Sub: Modification in earth fault circuit for elimination of spurious messages on account of earthing of control cables in 3-phase locomotives.

# Modification Sheet No. RDSO/2019/EL/MS/0480, (Rev.0)

Modification in earth fault circuit for elimination of spurious messages on account of earthling of control cables in 3-phase locomotives.

[Existing Earth Fault Circuit]

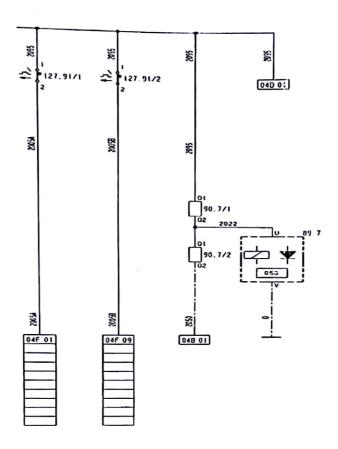
At present the locomotive battery earth fault detection circuit has two centre points' earthed R-R resistors and this causes a potential of 48V on any cable after touching to ground. The scheme is placed at Fig-1

[Modified Earth Fault Circuit]

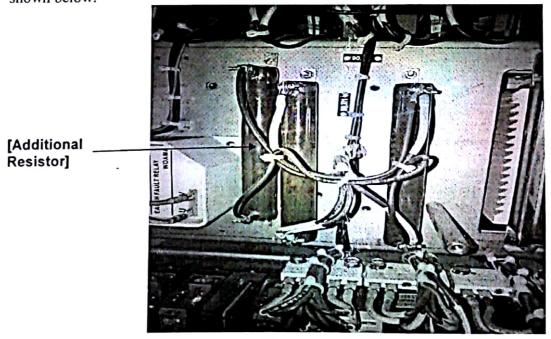
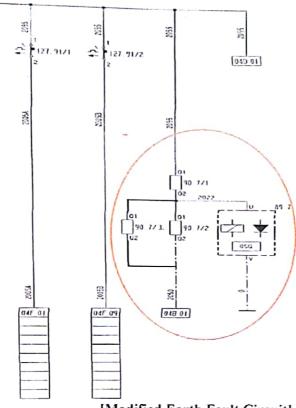
Now by changing the resistors to 2R-R or R-R/2 instead of R-R, the rise of potential in the event of earth fault can be reduced to 35V which is not considered as signal high by the card and spurious failures on account of earth fault can be avoided. The modified circuit is placed at Fig-2 and in image of modified arrangement of EFR is shown below:

Diverter Resistance (90.7/3) 390Ω/100W - 1Nos.
